Re: Tahmoor South Amended Project – Surface Water Impacts – Department of Planning, Industry & Environment Request for Information No. 1

Further to your email of 4 September, we have prepared the following responses to the above Request for Information (RFI) that relate to surface water issues for the Tahmoor South Amended Project.

Figure 8 Recorded and Modelled Flows Bargo River Upstream (GS 300010a) – 2014/15

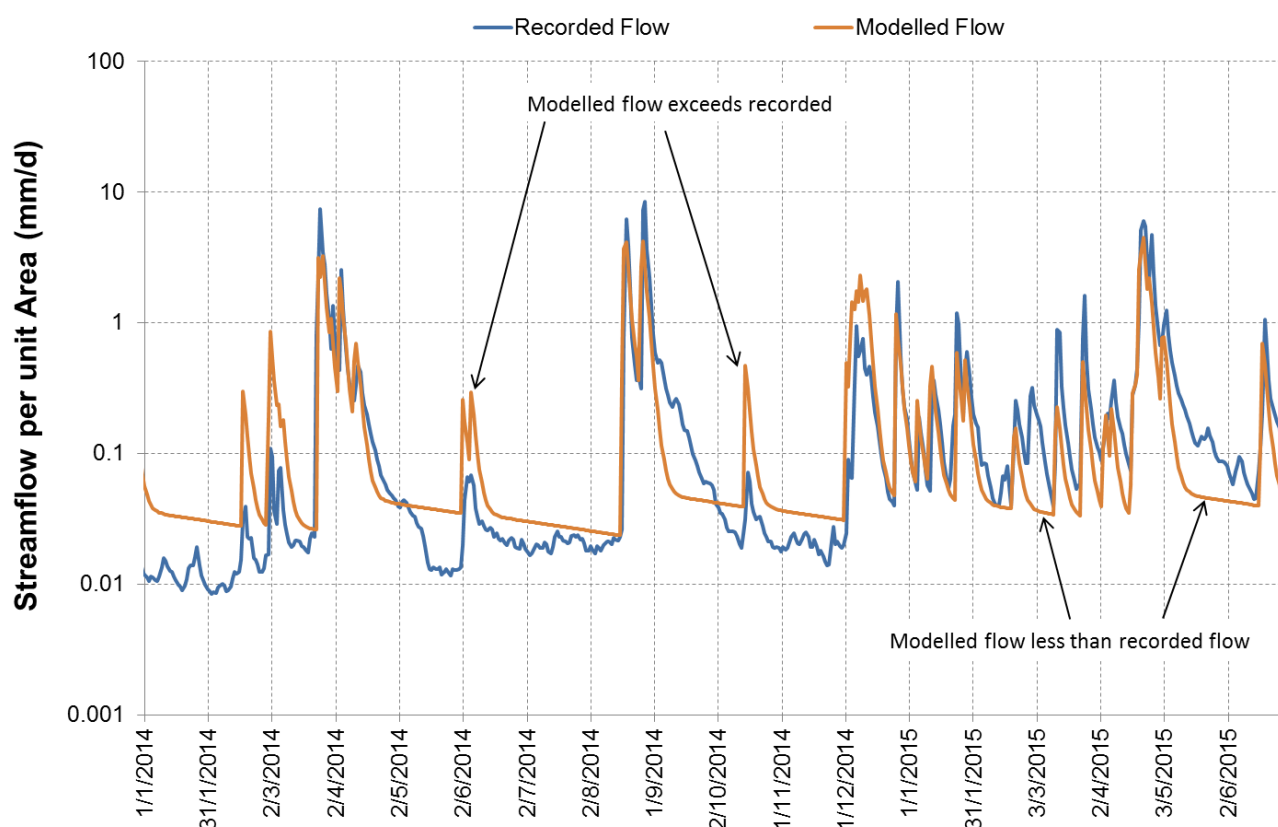
Bargo River US – “Model overestimating flows at times”.

Agreed. The modelled streamflows underestimate recorded data at times and overestimate recorded data at other times. No hydrological model can reliably reproduce recorded behaviour at all times. Figure 8 below shows examples for the same period as the third plot on this slide.

Figure 9 Recorded and Modelled Flows Bargo River Upstream (GS 300010a) – 2018/19

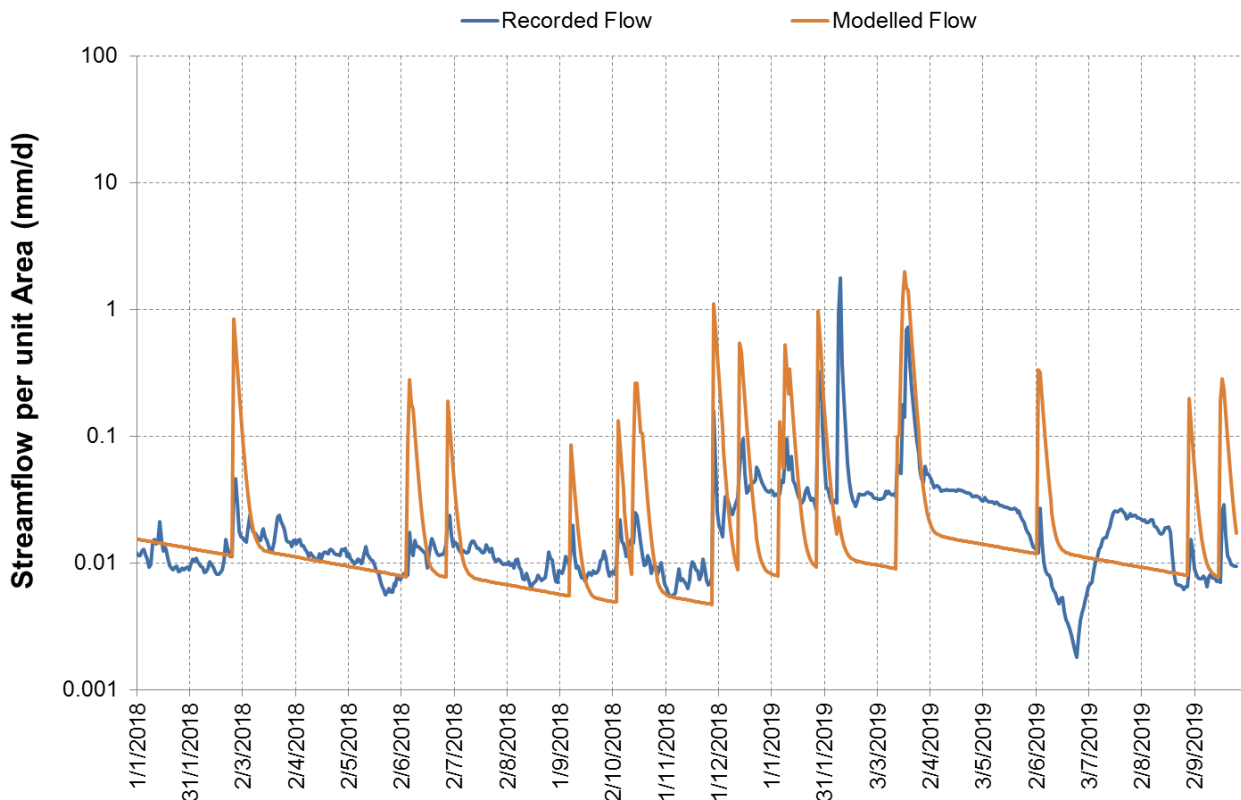
“Looks like serious datum change”

“What’s this??”

This comment appears to relate to the period of recorded data from December 2018 to August 2019. The hydrograph is shown in Figure 9 below for completeness.

There is a clear increase in recorded flow (stream water level – of approximately 5 cm) in December 2018 and a clear drop in around June 2019. HCS were unable to explain the rise, although they indicated that the behaviour in around June 2019 may be related to flow extraction from the river upstream.

The period of data in question is approximately 266 days in duration which represents less than 10% of the recorded data period presented. Recording of streamflow in natural streams is subject to the vagaries of electronic recording equipment – instrumentation can and does malfunction – as well as other issues such as vandalism, temporary blockage of controls, extraction from or discharge to the stream. Short periods of poor data do not invalidate data collected over a long period of time. The removal of this period of data does not change the coefficient of determination on monthly flows of 0.72 given in the SWIA report. It is noted that the calibration metrics given in Vaze et al. (2011) indicate that a satisfactory performance rating has been achieved for model calibration for this gauging station.

Figure 10 Flow Frequency Duration Plots – Bargo River Upstream (GS 300010a)

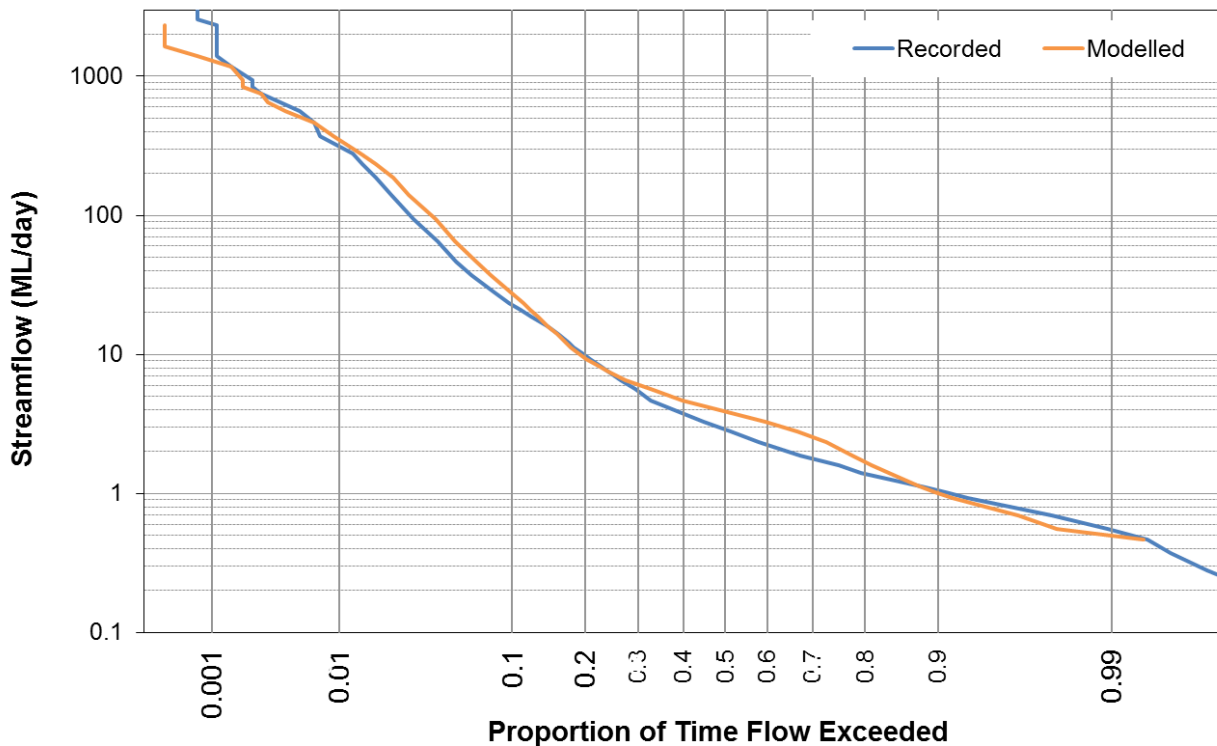
Flow exceedance curve presented indicating a mis-match between recorded and modelled flows for Bargo River Upstream (GS 300010a).

The plot shows a very narrow flow range (less than 5 ML/d), with flow plotted on an arithmetic scale. It is common and standard practice in hydrology to plot flows on a log scale so that the full range of flows can be readily assessed. The full flow duration curve is shown in Figure 10 below.

When considering the full range of flows, including low flows (less than 1 ML/d) it may be seen that there are ranges of flows where the model overestimates recorded flows and other flows where recorded data are underestimated. Over the full flow range the modelled flow exceeds recorded flow by 5% which is in line with recommendations in Vaze et al. (2011). Model calibration was confounded by the lack of rainfall data from within the catchment (model calibration used SILO Point Data⁹ for the catchment) – refer response to Slide 19 below.

Figure 11 Modelled and Recorded Monthly Streamflow - Bargo River Upstream (GS 300010a)

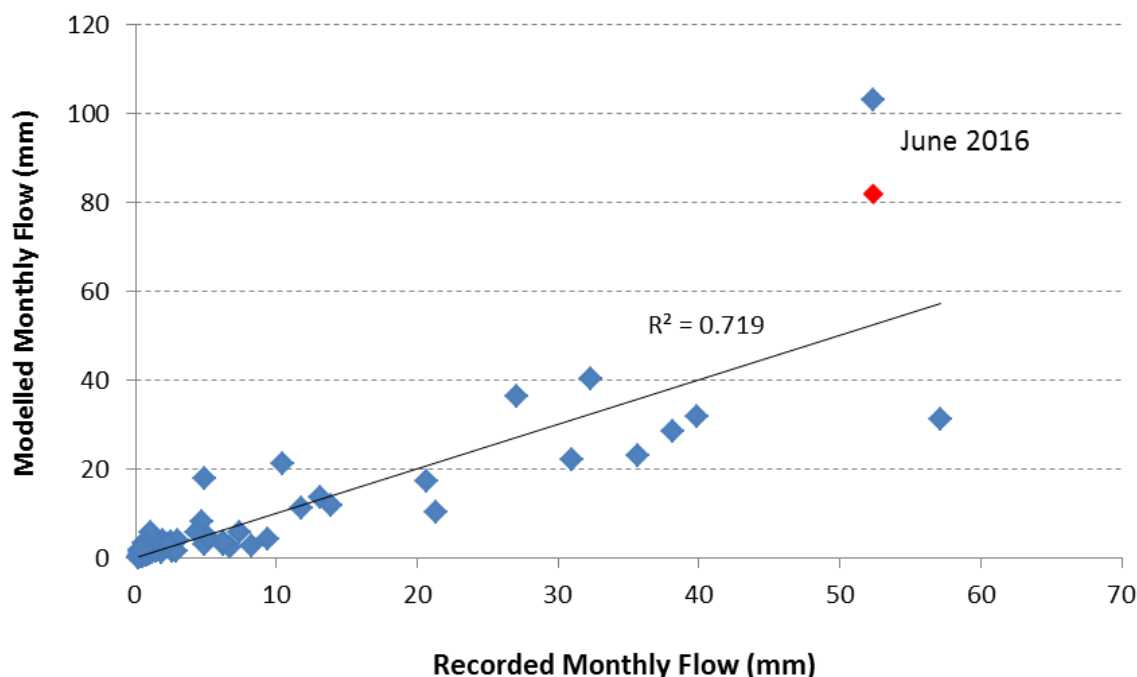
“Poor correlation between Measured Flow and Modelled Flow for Bargo US”

Figure 11 below shows a plot of modelled and recorded monthly streamflow for the period of calibration.

The data in Figure 11 show an outlier in the month of June 2016. The majority of the rainfall in that month occurred on the first weekend when the coast of New South Wales was affected by an East Coast Low. Table 1 summarises daily rainfall totals for that period from various nearby rainfall stations. The locations of the rainfall stations relative to creek catchment areas are shown in Figure 12.

significant, with modelled flow reducing (refer red point in Figure 11), the coefficient of determination on monthly flows for the calibration period increasing to 0.789 and the model matching recorded flows to within 0.6%.

Figure 13 Modelled and Recorded Monthly Streamflow – Eliza Creek (GS 300073)

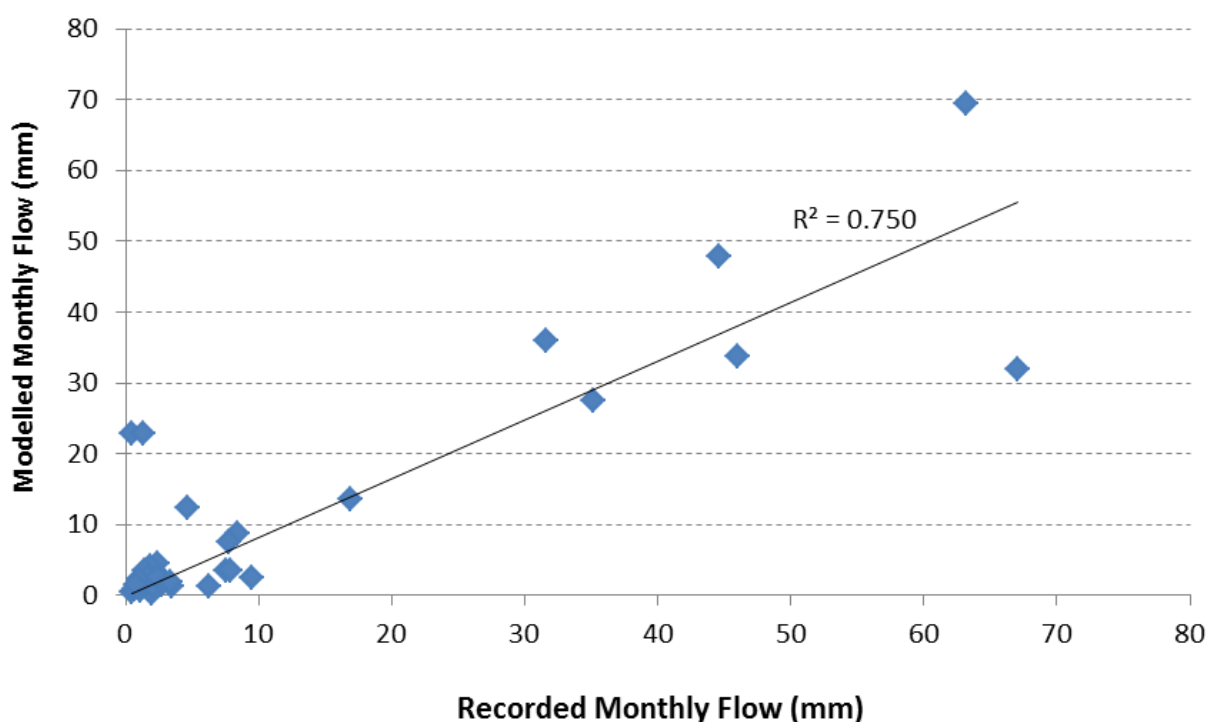
“Eliza Ck – Poor fit between observed and modelled data. No observed data at all”

“Very poor correlation between Measured Flow and Modelled Flow for Eliza Ck”

Figure 13 below shows a plot of modelled and recorded monthly streamflow for the period of calibration, indicating a generally good model fit. Model calibration was confounded by the lack of rainfall data from within the catchment (model calibration used SILO Point Data¹⁰ for the catchment).

It is agreed that at times there is a mis-match between recorded and modelled daily flows for periods of time greater than a day (i.e. more than would result from rainfall temporal and spatial variability). It is noted that the catchment of Eliza Creek comprises mainly of rural acreage properties and that flows may be affected by the presence of farm dams on these properties as well as by creek extraction. As more data is recorded, the calibration of the Eliza Creek model should be refined ahead of the development of the Tahmoor South Project.

Figure 13 shows a plot of modelled and recorded monthly streamflow for the period of calibration, indicating a generally good model fit.

Figure 14 Flow Frequency Duration Plots – Eliza Creek (GS 300073)

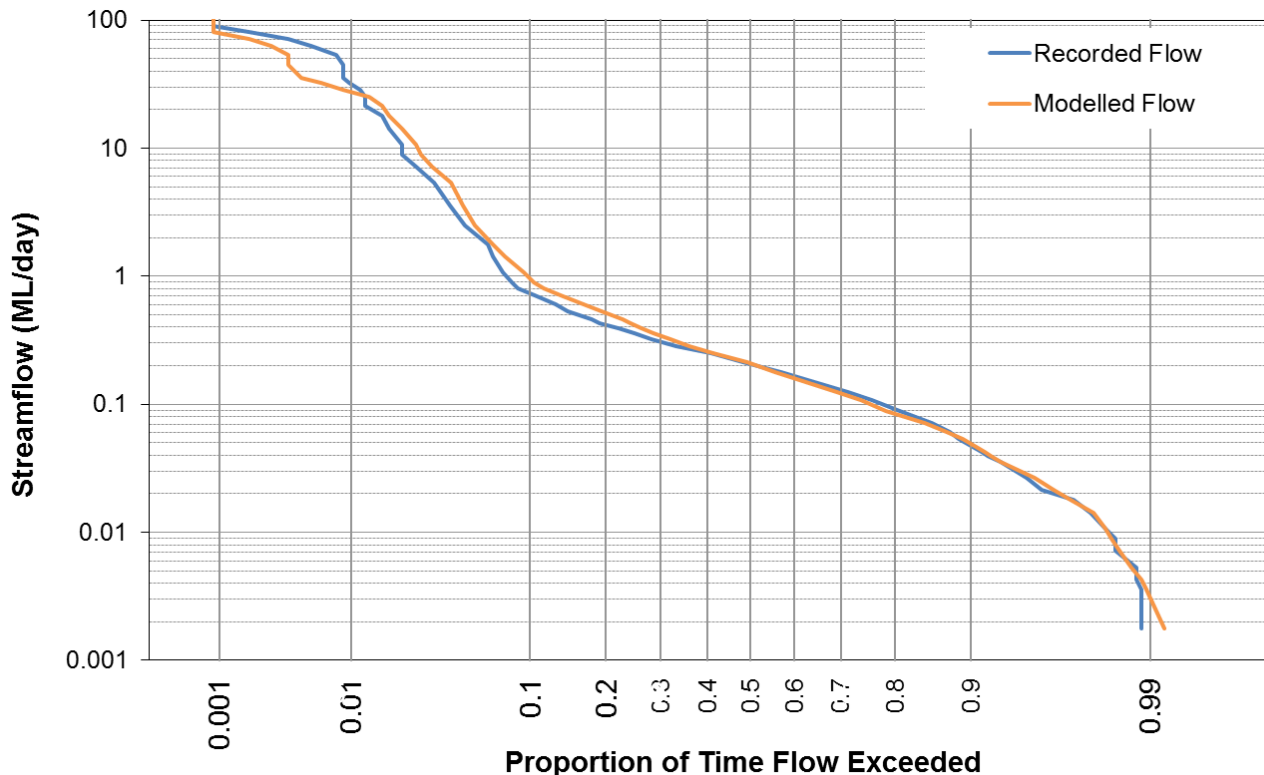
Flow exceedance curve presented indicating a mis-match between recorded and modelled flows for Eliza Creek (GS 300073).

The plot shows a very narrow flow range (less than 5 ML/d), with flow plotted on an arithmetic scale. It is common and standard practice in hydrology to plot flows on a log scale so that the full range of flows can be readily assessed. The full flow duration curve is shown in Figure 14 below.

The median flow rates stated in Slide 21 (presumably based on daily data) are 0.21 ML/d (recorded) and 0.13 ML/d (modelled). Our calculations indicate median flow rates of 0.21 ML/d for both recorded and modelled data for the period of model calibration. The median modelled value of 0.13 ML/d given in Slide 21 appears to have been calculated for the entire period of modelled data spanning November 2012 to September 2018 including the more than 2½ year period of no data record. It is inappropriate and misleading to compare two median values that have been calculated over different periods of record. The plots shown on Slide 21 similarly appear to compare two different periods of data – such a comparison is meaningless.

Figure 15 Recorded and Modelled Flows Dog Trap Creek D/S (GS 300063) – 2013/14

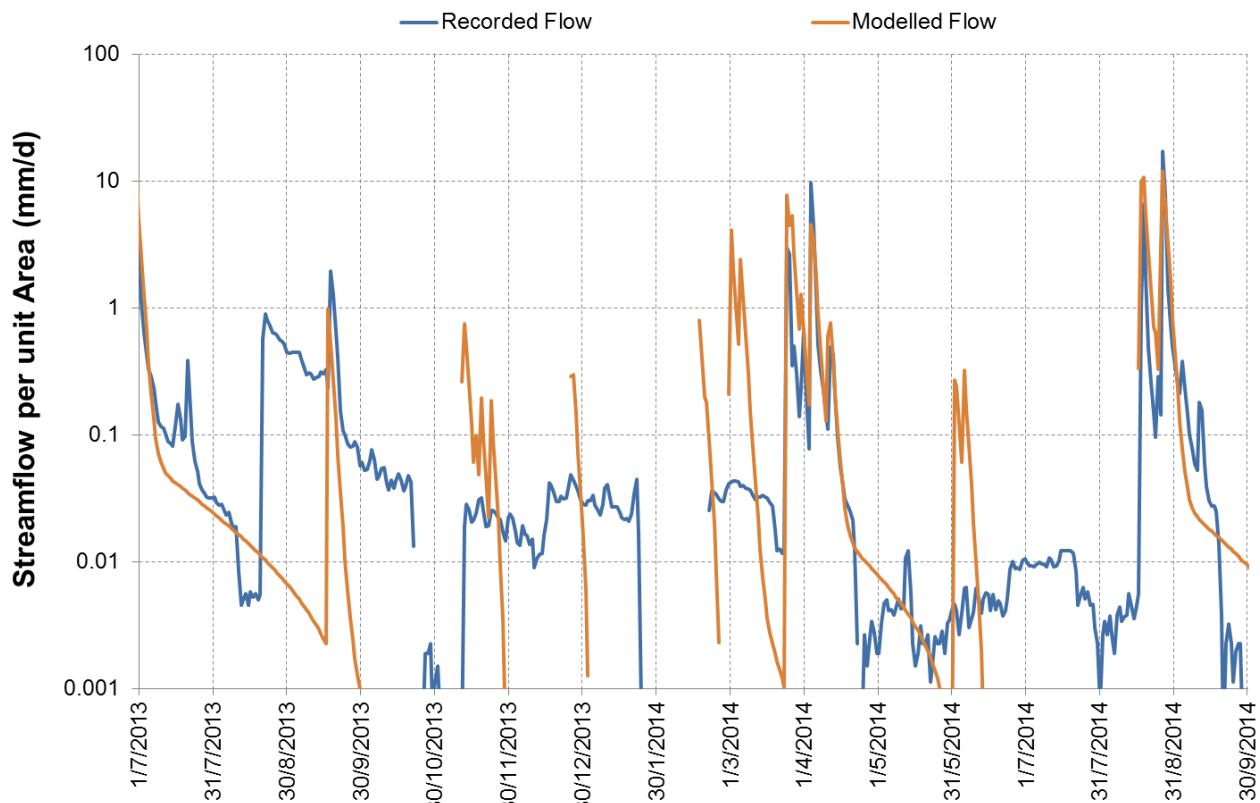
Dog Trap Creek “Very Poor fit between observed and modelled data – or is it datum change? No observed data at all”

The period of data highlighted as “Very Poor fit between observed and modelled data – or is it datum change?” is interpreted as being from July 2013 to September 2014. The hydrographs for this period are plotted in Figure 15 below.

There is a clear rise in recorded water level (used to calculate streamflow) on 21 August 2013. For the period up to late March 2014 HCS have indicated that there was no flow observed during their visits to the station. This is confirmed by comparison with the concurrent streamflow record from GS 300064 (Dog Trap Creek U/S) – plotted in Figure 16. Therefore it is concluded that the recorded data is erroneous for this period (of approximately 216 days).

Figure 17 Flow Frequency Duration Plots – Dog Trap Creek (GS 300063)

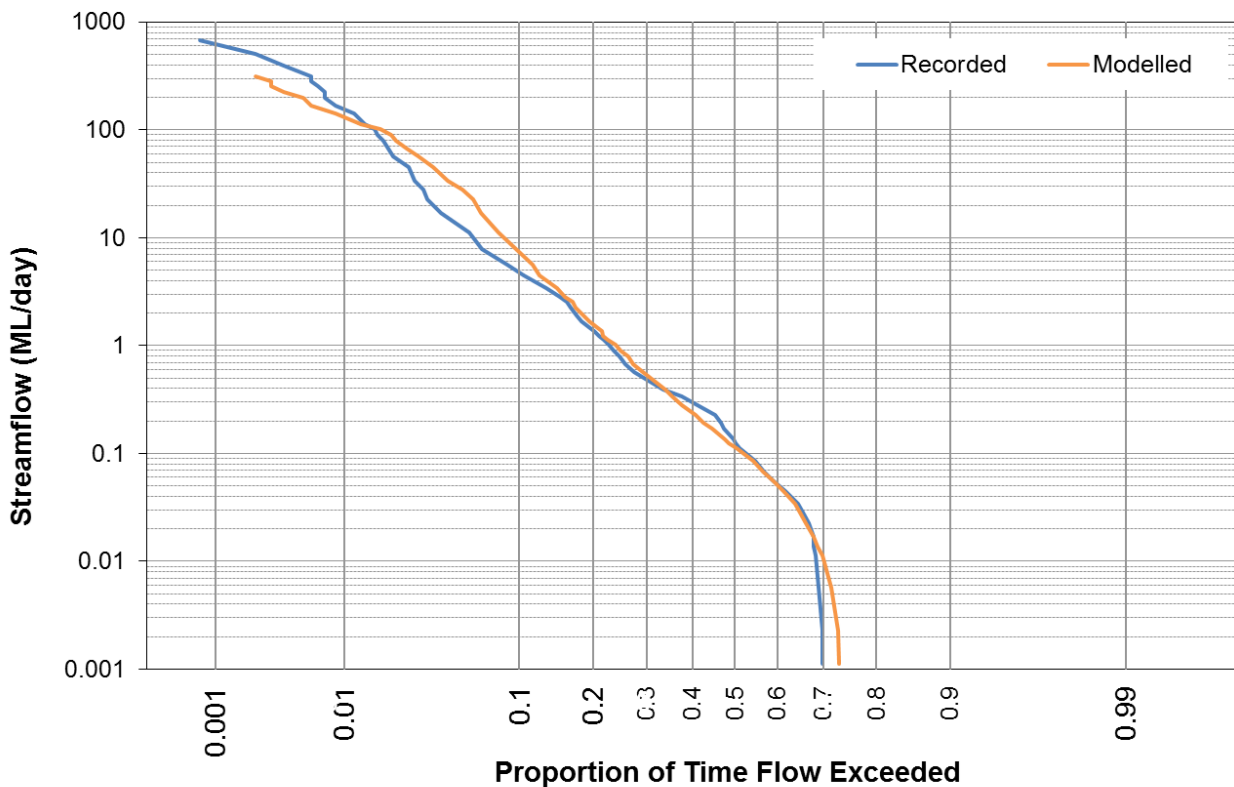
Flow exceedance curves presented. Second plot appears to be for data for GS 300064 and GS 300063 for the period March 2014 to August 2015. The following is unclear:

The first plot shows a narrow flow range (less than 5 ML/d), with flow plotted on an arithmetic scale. It is common and standard practice in hydrology to plot flows on a log scale so that the full range of flows can be readily assessed. The full flow duration curve is shown in Figure 17 below.

The median flow rates stated in Slide 26 (presumably based on daily data) are 0.12 ML/d (recorded) and 0.04 ML/d (modelled). Our calculations indicate a median flow rate of 0.13 ML/d (recorded) and 0.11 ML/d (modelled) for the period of model calibration. The median modelled value of 0.04 ML/d given in Slide 26 appears to have been calculated for the entire period of modelled data spanning February 2012 to April 2019 including the 3¼ year period of no data record. It is inappropriate and misleading to compare two median values that have been calculated over different periods. The plots shown on Slide 26 similarly appear to compare two different periods of data and such a comparison is meaningless.

Figure 18 Modelled and Recorded Monthly Streamflow – Dog Trap Creek (GS 300063)

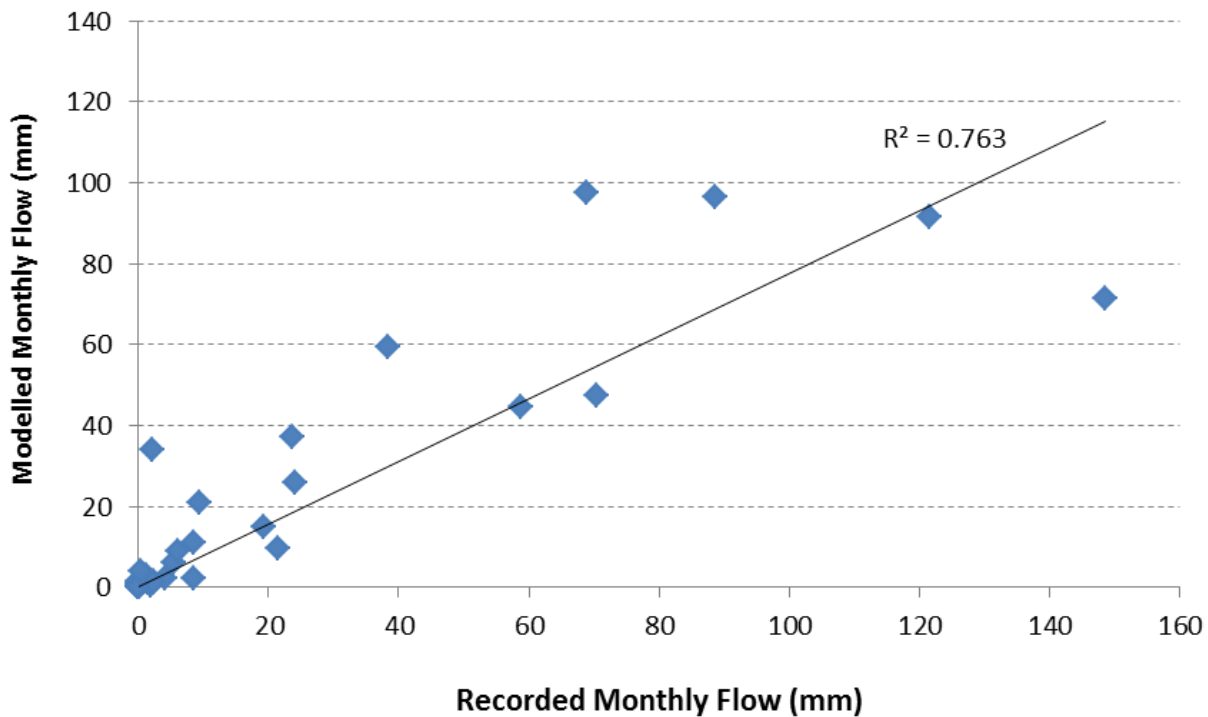
“Very poor correlation between Measured Flow and Modelled Flow for Dog Trap Creek”

Figure 18 shows a plot of modelled and recorded monthly streamflow for the period of calibration, excluding the period of erroneous data described in the response to Slide 24, indicating a generally good model fit.
